**TO:** Montgomery County Planning Board  
**VIA:** Glenn Kreger, Acting Chief *HK*  
Community-Based Planning Division  
**FROM:** Sue Edwards, Team Leader, I-270 Corridor *Sue*  
Community-Based Planning Division (301-495-4518)  
**SUBJECT:** Worksession #2 Germantown Master Plan

SUBJECT: Germantown Master Plan – Worksession #2  
Area Wide Urban Design Recommendations

SUBJECT: Germantown Master Plan  
Worksession #2  
Transportation Discussion Topics

**Urban Design Framework**

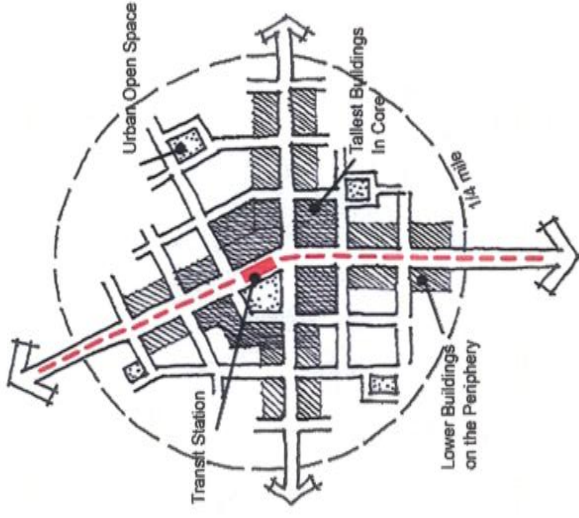
**Public Testimony:** Sub centers within Districts are needed. The Town Center is too large an area to be developed with a uniform density.

1. Revise the Framework Map on page 15 to identify the core neighborhood within the Town Center as the focus of economic strength and synergy. See Revised Urban Framework Map, Attachment B.

A hierarchy of centers is needed for Germantown with the Core Neighborhood achieving highest density and diversity of uses. The revised graphic better illustrates the Plan’s recommended hierarchy of density.

Replace Urban Design Framework Map, page 15.

## Existing and Proposed Street Network

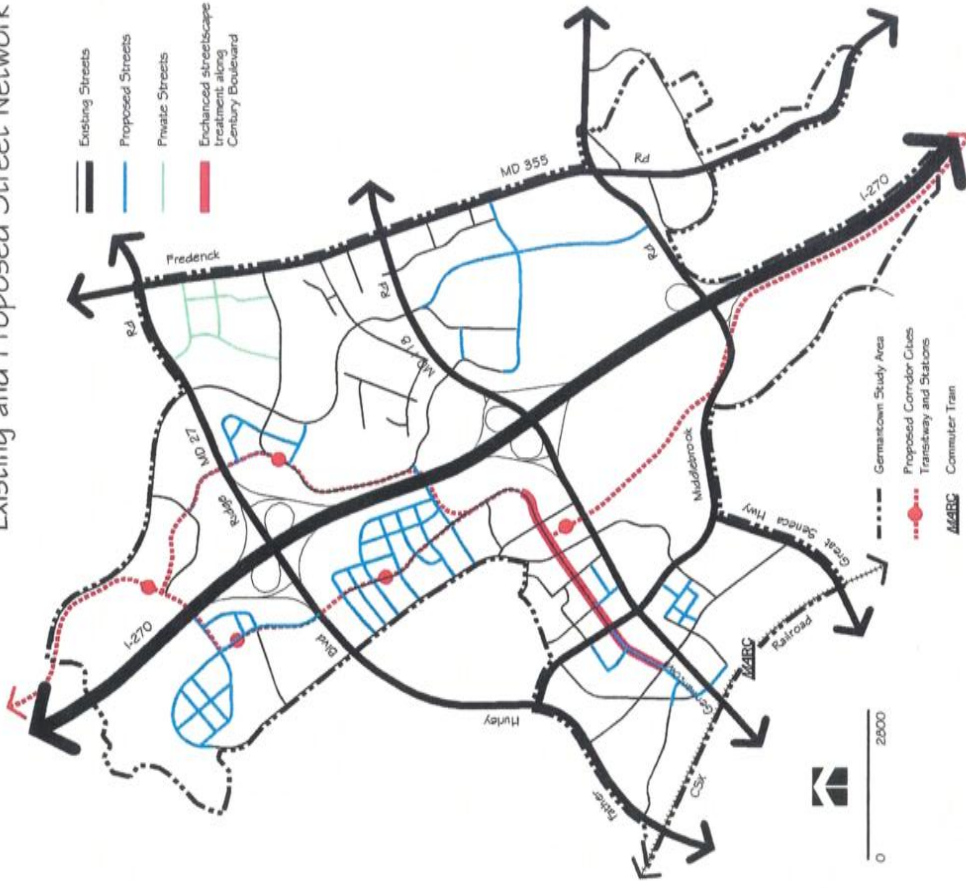
**Public Testimony:** Cannot understand this section. Need to emphasize transit and pedestrian friendly street design. (Lindstrom)  
Short block lengths recommendations are too rigid, cannot always achieve as a standard. (Smith)

Improve understanding of the Plan's extensive proposed street network and trail connections by adding the Street Network Map, Boulevards and Main Street Map and a bikeway, trail connection map showing connections to the greater community. The illustrative cross sections need to appear adjacent to the Boulevards and Main Street Map to explain the character of these streets. The Plan supports short block lengths to encourage walking but also allows for flexibility in block lengths to meet individual situations.

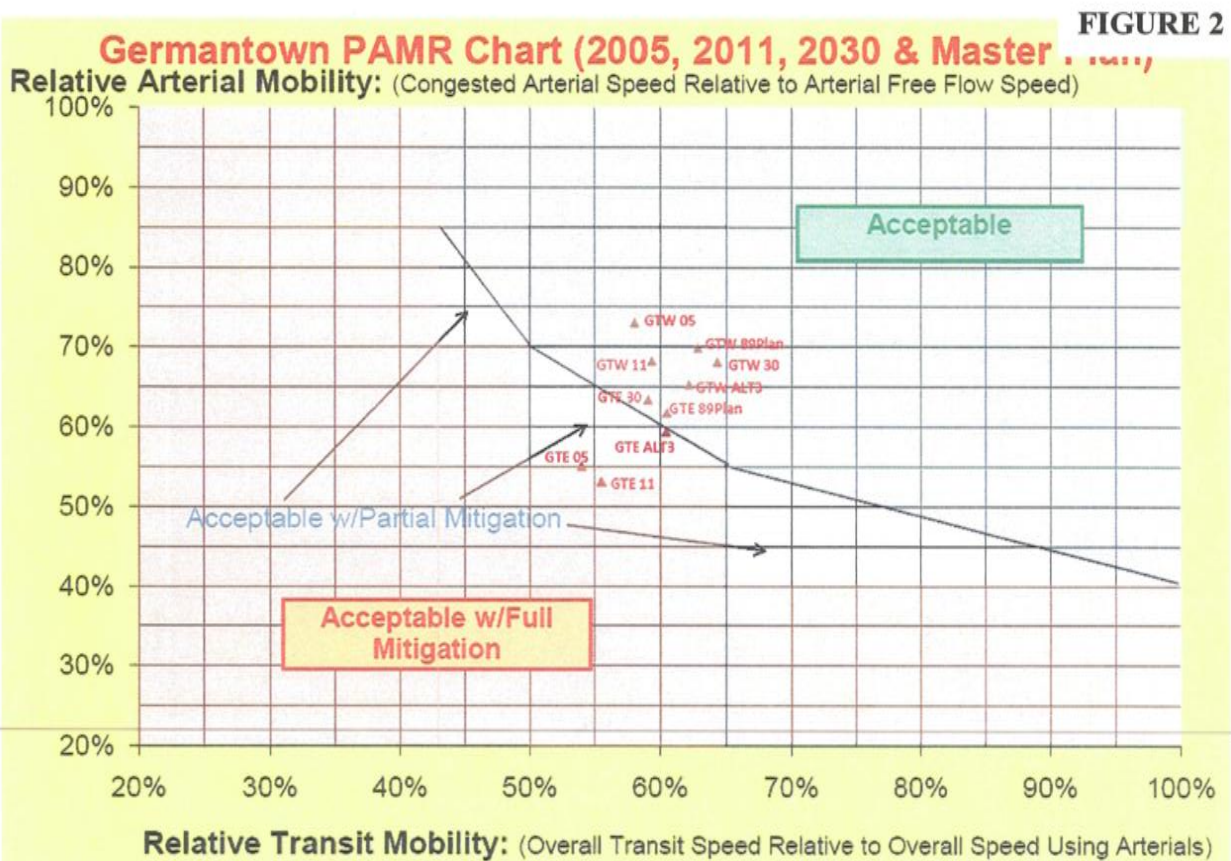
Figure 2 shows the results of the PAMR analysis, comparing conditions for 2005, 2011, and Alternative 3, the working title for the highest amount of land use tested during alternatives analysis. The plan’s recommended land use is commensurate with, but slightly lower than, that tested as Alternative 3. Figure 2 uses the following nomenclature to identify forecast Relative Transit Mobility (RTM) and Relative Arterial Mobility (RAM) conditions:

The objective of the master plan balance assessment is to ensure that the end-state conditions are acceptable with either partial or full mitigation. In other words, the GTW ALT3 and GTE ALT3 markers both need to be “above the staircase” and in either the white or green areas on the chart in Figure 2. The PAMR analysis allows us to conclude that while the recommended land use and transportation system is slightly more congested than that in the 1989 Plan, that both the Germantown East and the Germantown West Policy Areas have adequate mobility scores and that the recommended plan therefore has a balance between land use and transportation.
